# Comment #83 – “Black Link” Comment Discussion

July 9, 2020

Joint IEEE P802.3ct / P802.3cw Interim Teleconference Meeting

Figure 154–1—100GBASE-ZR PMD relationship to the ISO/IEC Open Systems Interconnection (OSI) reference model and IEEE 802.3 Ethernet model

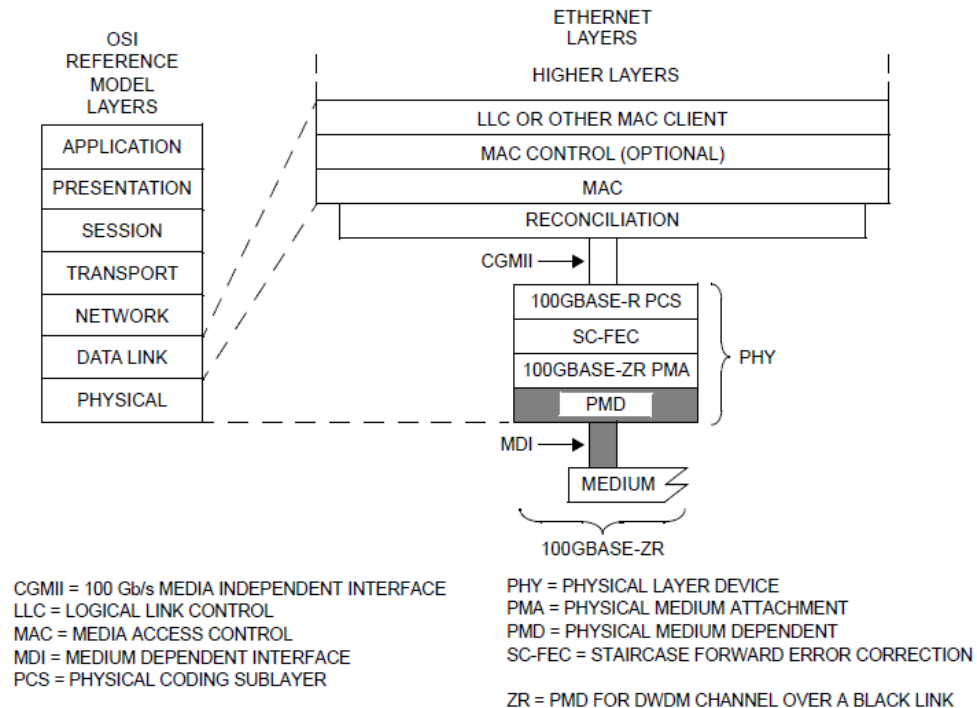
“black link” is how we describe the DWDM channel / medium – it is not the medium.

Suggest  
 ZR= PMD for DWDM System – 80 km

Figure 154–3—Example configuration of the black link approach

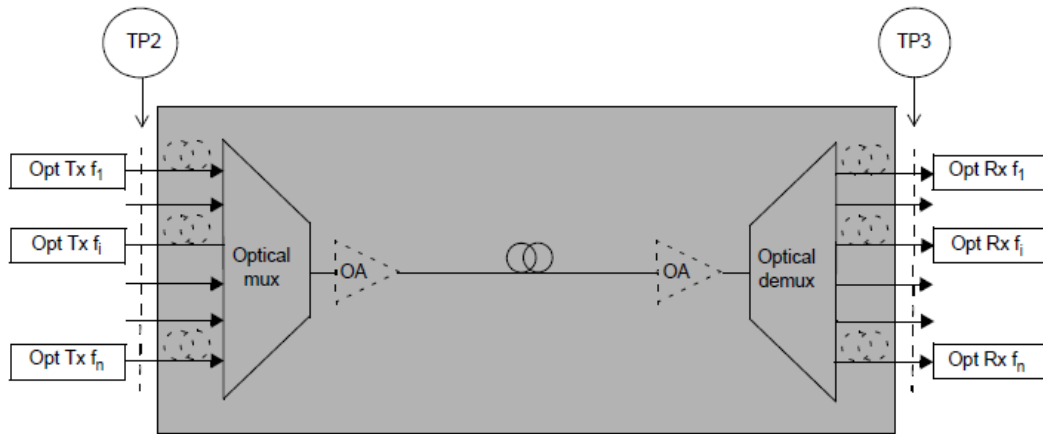
but also not specifically excluded as long as the end-to-end link requirements are met. The arrangement of (DWDM) elements within the black link shown in Figure 154–3 is not intended to place constraints on the construction of the black link, but simply to define the location of the single channel interfaces at TP2 and TP3.

- Black link isn't constructed – the DWDM channel or system is
- Suggest
- The arrangement of (DWDM) elements within the black link shown in Figure 154–3 is not intended to place constraints on the construction of the DWDM channel or system, but simply to define the location of the single channel interfaces at TP2 and TP3.
